Access Compliance Report

Public Rights-of-Way

(Curb Ramps)

Intersection ID: 18726	Main Street: TYVOLA_RD	Cross Street: OLD_PINEVILLE_RD	Location: NE
ADA ID: 4201484862E5	Ramp Type: Perp	Initial Pass/Fail: Fail	Overall Compliance: No
Severity Score: 21.25			
Codes/Mitigation Info/Possible Solution		Field Measurements/Component Compliance

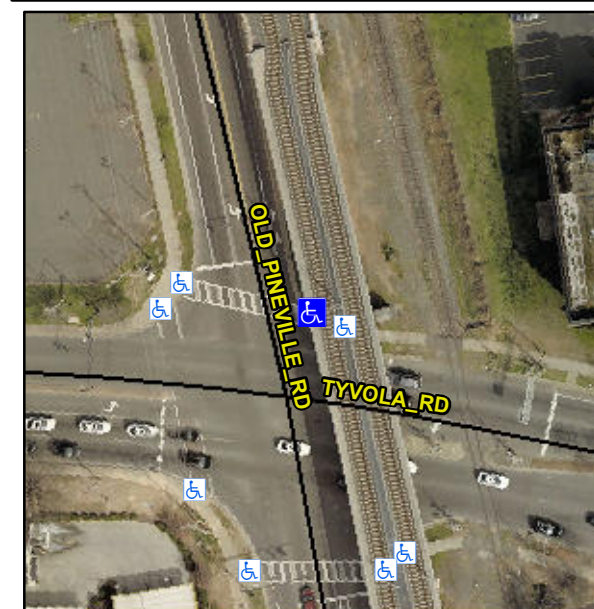
Not Found, R304.5.1, R304.2.2

Compliance	Description	Data	Compliance	Description	Data
N/A	Ramp Length (in)	71.0	No	Ramp Slope (%)	9.3
No	Ramp Width (in)	46.5	Yes	Ramp XSlope (%)	0.1
N/A	Flare Type LT	N/A	N/A	Flare Type RT	N/A
N/A	Flare Slope LT (%)	N/A	N/A	Flare Slope RT (%)	N/A
N/A	Flare Traversable LT?	N/A	N/A	Flare Traversable RT?	N/A
N/A	Landing Length (in)	N/A	N/A	DWS Provided?	N/A
N/A	Landing Width (in)	N/A	N/A	DWS Contrast?	N/A
N/A	Landing Slope (%)	N/A	N/A	DWS Length (in)	N/A
N/A	Landing X Slope (%)	N/A	N/A	DWS Full Width?	N/A
N/A	Landing Curb? (Y/N)	N/A	N/A	DWS Offset (in)	N/A
N/A	Shared Landing?	N/A			
N/A	Gutter Ponding?	N/A	N/A	Gutter Slope (%)	N/A
N/A	Gutter Lip Ht (in)	N/A	N/A	Gutter X Slope (%)	N/A
N/A	Painted X Walk1?	No	N/A	Painted X Walk2?	N/A
	X Walk 1 Direction	To NW		X Walk 2 Direction	N/A
N/A	X Walk 1 Width (in)	N/A	N/A	X Walk 2 Width (in)	N/A
	X Walk 1 Slope (%)	1.7		X Walk 2 Slope (%)	N/A
	X Walk 1 X Slope (%)	0.0		X Walk 2 X Slope (%)	N/A

Remove & Replace Entire Ramp.
